Memorandum

SUBJECT: HPC Review of RA Long Park Master Plan Changes

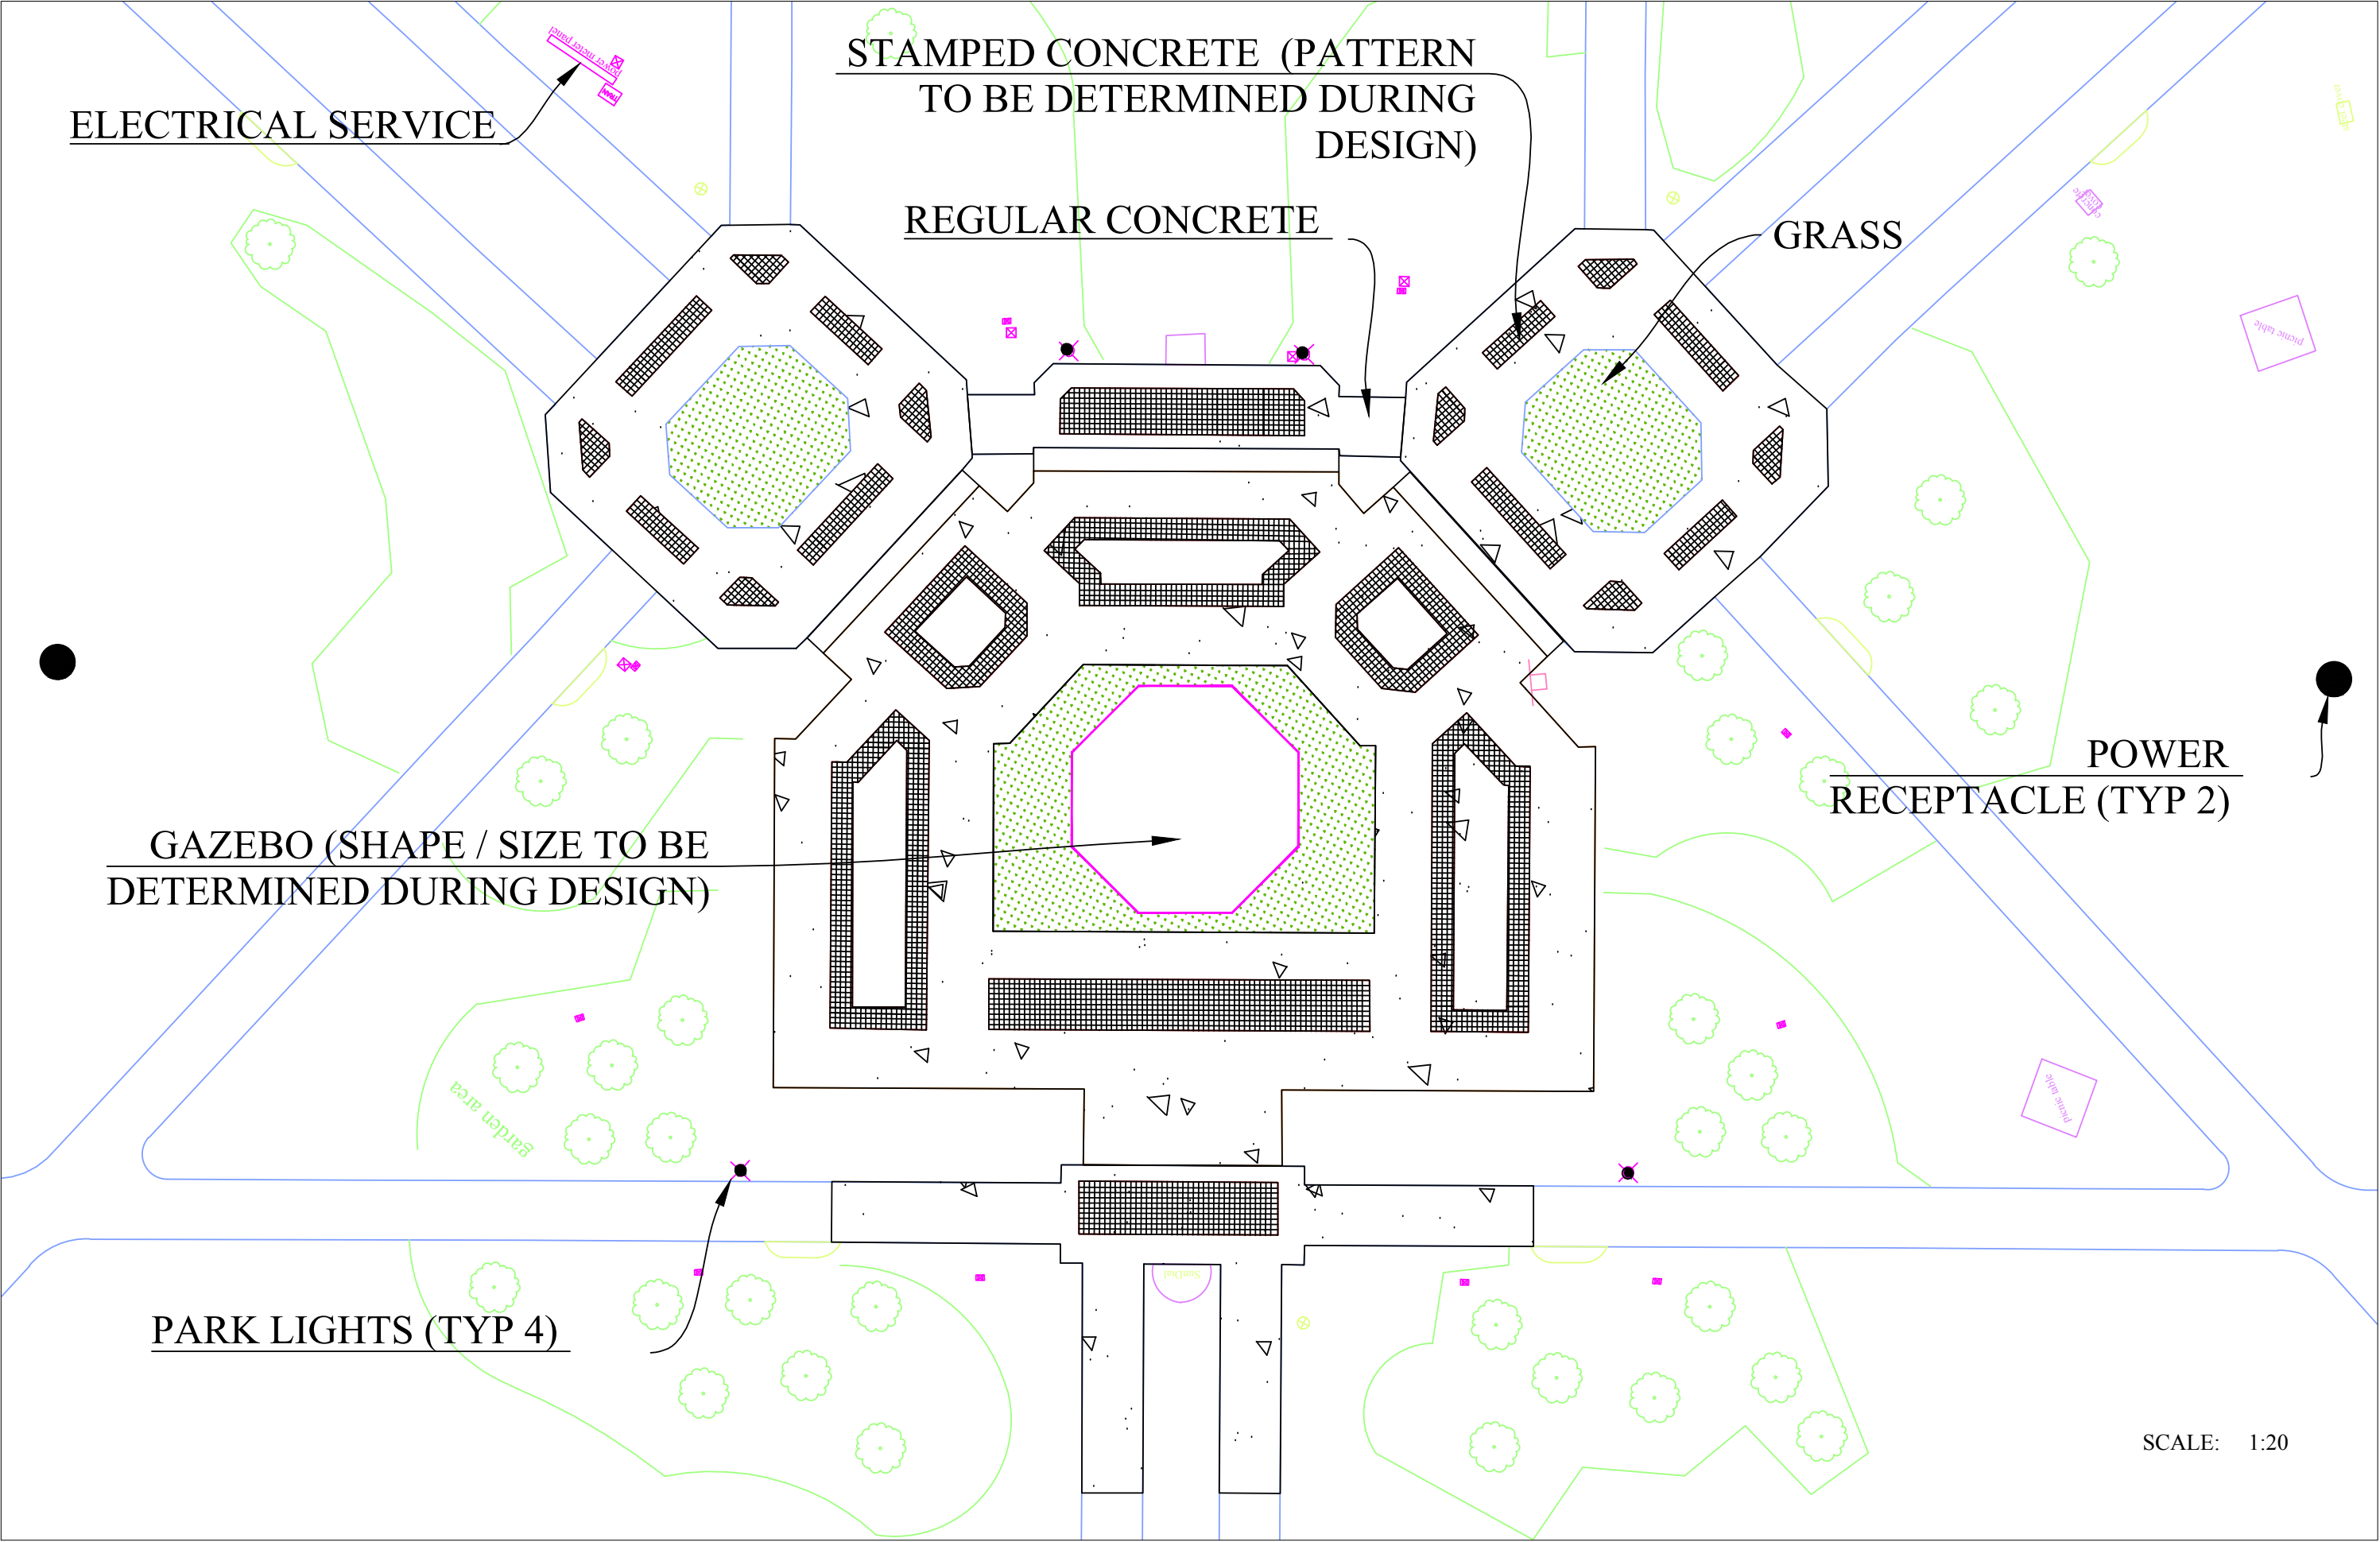
The motion by the commission also found the following design elements are significant and need to be replaced:

1. The plaza elevation
2. The plaza shape / geometry
3. The scoring / texture of the concrete to match original
4. The hedge border

The gazebo design and final concrete stamping/scoring pattern will need design review and approval. The members of the commission preferred the oval or octagonal gazebo option rather than a pavilion.
